ECE/TRANS/WP.29/GRE/2009/66
17 July 2009

Working Party on Lighting and Light-Signalling

COLLECTIVE AMENDMENTS

Proposal for draft Supplements to Regulations Nos. 6, 7, 48, 77 and 91

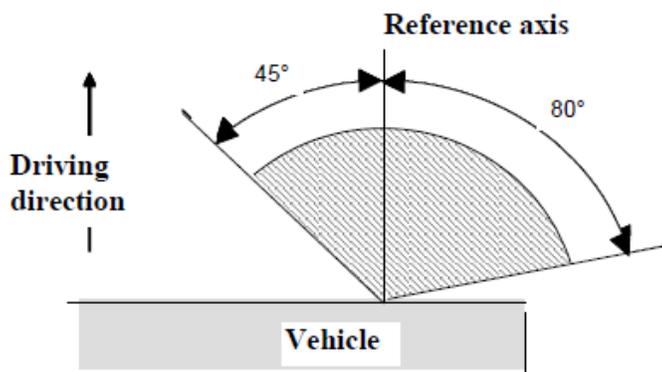
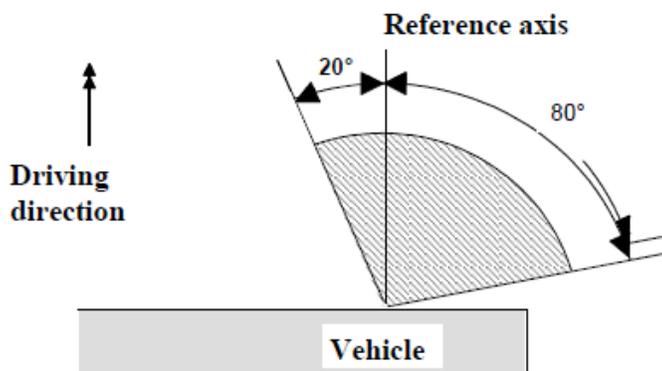
On and above the H plane
for all lamps.

Under the H plane for

lamps intended for:

(a) M₂, M₃ or N₂ category
of vehicles or

(b) M₁ or N₁ category of
vehicles and being
installed at a mounting
height of equal to or more
than 750 mm above the
ground.

Under the H plane for

lamps intended for M₁ and
or N₁ category of vehicles,
and being installed at a
mounting height less than
750 mm above the
ground.

Front position lamps, End-outline marker lamps

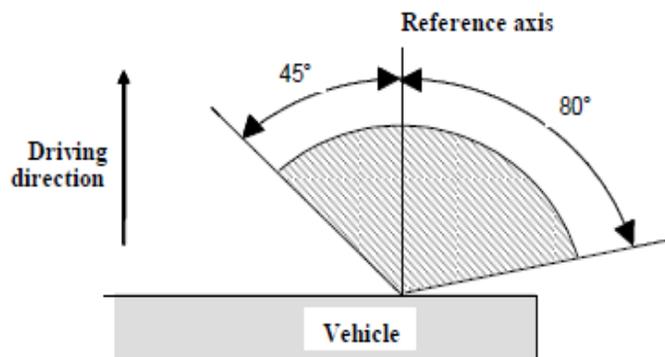
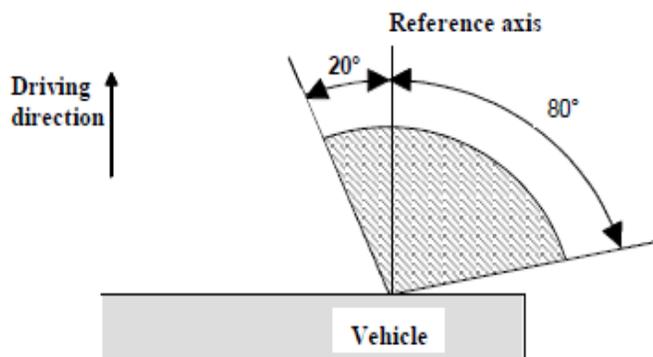
On and above the H plane for all lamps.

Under the H plane for lamps intended for;

(a) M₂, M₃, N₂ or N₃ category of vehicles or

(b) M₁ or N₁ category of vehicles, and being installed at a mounting height of equal to or more than 750 mm above the ground.

Under the H plane for

lamps intended for M₁ and or N₁ category of vehicles, and being installed at a mounting height less than 750 mm above the ground.

FIGURE (see paragraph 6. 5.)

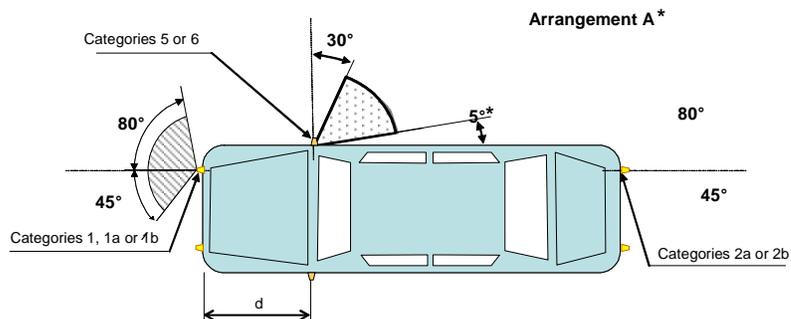
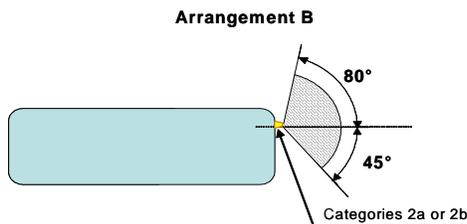
For M₁ and N₁ category vehicles, the value of 45° inward for the direction indicator lamps of categories 1, 1a or 1b, whose lower edge of the apparent surface is less than 750 mm above the ground, may be reduced to 20° under the horizontal plane containing the reference axis of this lamp.

For M₁ and N₁ category vehicles, the value of 45° inward for the direction indicator lamps of categories 1, 1a or 1b, ~~whose lower edge of the apparent surface is~~ **if the lamps are** less than 750 mm above the ground, may be reduced to 20° under the horizontal plane containing the reference axis of this lamp."

Front and rear direction-indicator lamps, as well as side-marker lamps

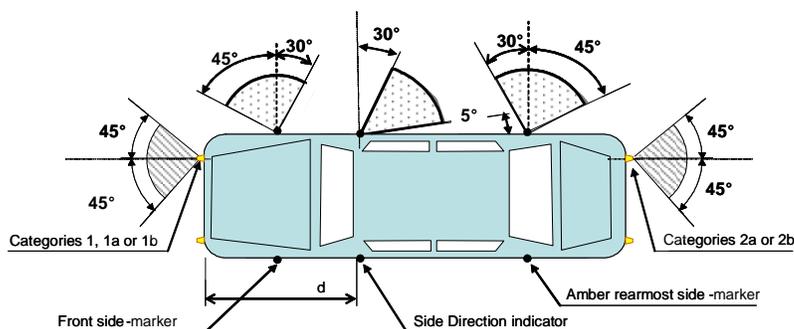
The value of 45° inward for the direction indicator lamps of categories 1, 1a or 1b, ~~whose lower edge of the apparent surface is~~ **if the lamps are less than 750 mm** above the ground, may be reduced to 20° under the horizontal plane containing the reference axis of this lamp.

Figure 1

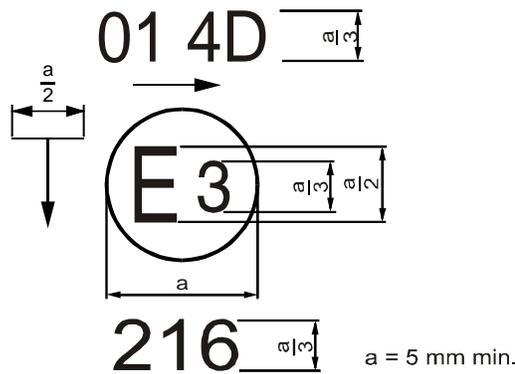
Vertical angles may be reduced if the lamps are less than 750 mm above the ground. According to paragraph 5.8., this means the highest point of the apparent surface is less than 750 mm . On the other hand, horizontal angles may be reduced if the lower edge of the apparent surface is less than 750 mm. Therefore, the requirement was aligned based on the definition of measuring the height in paragraph 5.8. has been aligned. In addition, the vertical arrow in the approval mark (see Figure 1) can be used as a symbol for horizontal angles reduction.
